# SPR EA1N and EA2 PROJECTS

## DEADLINE 9 – SUBSTATION DESIGN PRINCIPLES STATEMENT

**Interested Party:** SASES    **PINS Refs:** 20024106 & 20024110

**Date:** 15 April 2021

Bramford Norwich-Stowell Turn-in	PARTNER	A1
	Options 1		CAD
	Bramford 400kV Substation	1-1000	
	Common	03/06/07	
242608/01E/005		1	P1

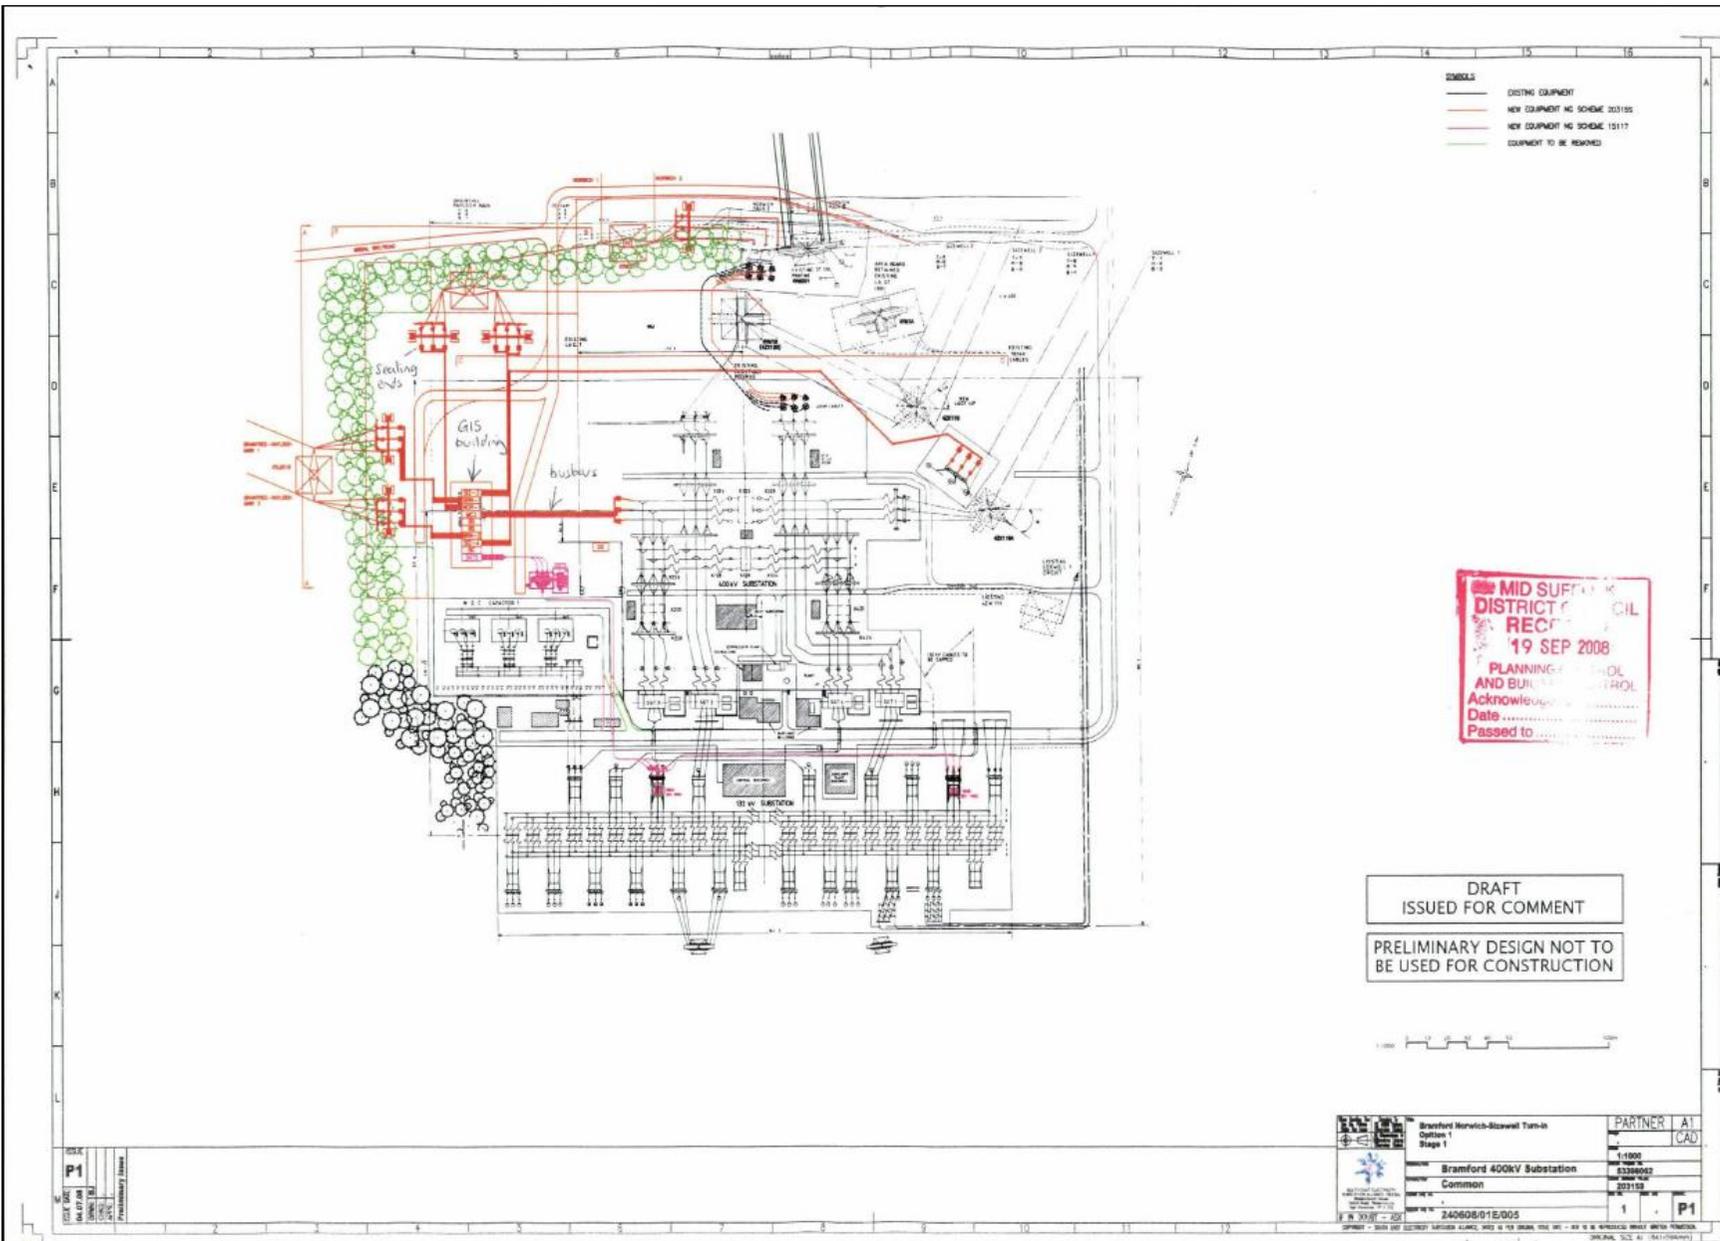
Further to our recent conversation, I enclose an A3 version of drawing 240608/01E/005/P1 which shows (in red) a revised proposal for Bramford substation. I write to seek your opinion on the permitted development status of this proposal.

The revised proposal is for a gas insulated switchgear substation, which means that the switchgear will be located in a building, the dimensions of which will be 10m by 21m by 12m high. This building will be connected to the sealing end gantries by gas insulated busbars which will stand 2-5m above ground level. The sealing end gantries will be up to 12.5m in height. Related plant and equipment will be below this height. In order to accommodate modifications to the security fence, a new access road will be constructed along the northern boundary of the site. This will however be less extensive than that previously proposed. A minor diversion of the bridleway will be required.

I would be grateful if you could confirm that the works shown in red on drawing 240608/01E/005/P1 may be considered permitted development. We will seek your approval of the design and appearance of the building in accordance with Class G2(d) once this has been finalised.
